Point Beach Nuclear Plant, Units 1 and 2
Dockets 50-266 and 50-301
Renewed License Nos. DPR-24 and DPR-27

License Amendment Request 261
Extended Power Uprate
Response to Request for Additional Information

LICENSE AMENDMENT REQUEST 261 EXTENDED POWER UPRATE RESPONSE TO REQUEST FOR ADDITIONAL INFORMATION

FIGURES FOR PBNP EPU LBLOCA BORON PRECIPITATION ANALYSIS

Figure 1: Liquid Velocity at Bottom of Low Power (LP) Core Channel

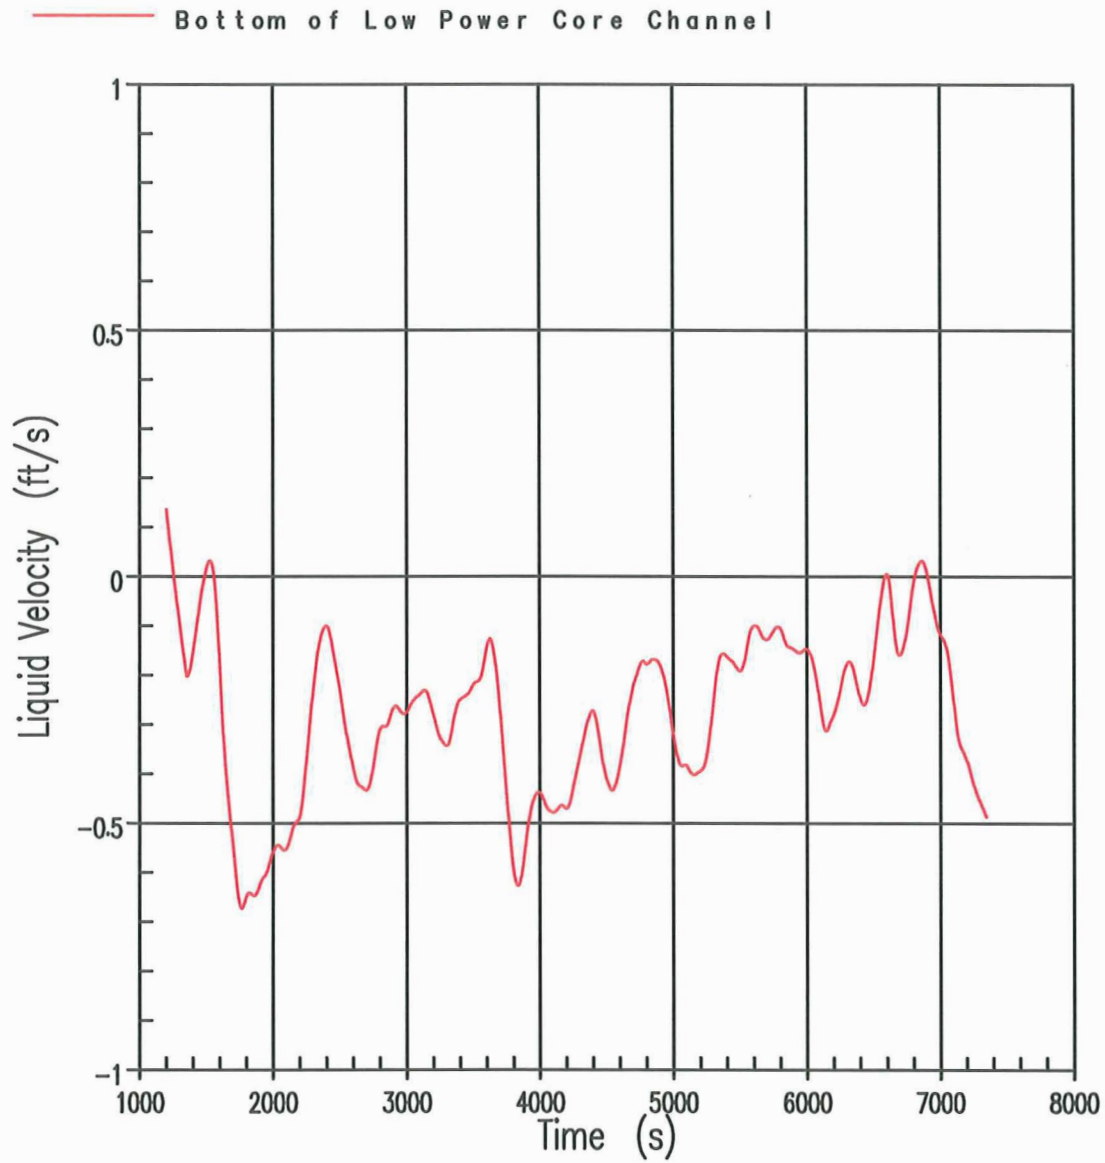
During a meeting on February 24 and 25, 2011, NextEra was requested to provide additional information regarding Point Beach Nuclear Plant (PBNP) post loss-of-coolant accident (LOCA) reactor vessel flow paths and flow velocities to enable continued review of the request. Enclosure 1 provides the NextEra response to the request for additional information.

WCOBRA/TRAC (WC/T) transient data for the PBNP extended power uprate (EPU) large break LOCA (LBLOCA) is shown in Attachment A, Figures 1 through 5. The WC/T transient data is obtained from the emergency core cooling system (ECCS) recirculation phase (>20 minutes from accident initiation) of an LBLOCA with the low head safety injection (LHSI) pumps injecting water into the reactor vessel upper plenum and the high head safety injection (HHSI) pumps secured. The figures demonstrate the expected thermal convection behavior – downflow from the low power core region to the lower plenum (Figure 1), predominantly upflow from the lower plenum to the average and high power core regions (Figures 2 through 4), and relatively stagnant flow at the lower support plate (Figure 5).
